43M-2148

SITING AND GRADING PLAN

DOLOMITE DRIVE **ROYAL PINE HOMES - 221070** FORESTSIDE ESTATES INC., BRAMPTON, ON.

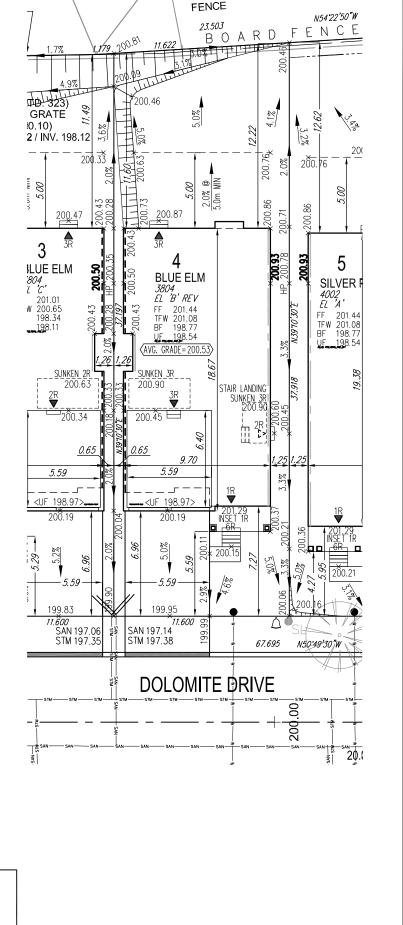
REVIEWED **REVIEWED AS MODIFIED** REVISE AND RE-SUBMIT FOR REVIEW NOT REVIEWED

Builder to verify lateral elevations prior to digging foundation.
SEPT. 19, 2023
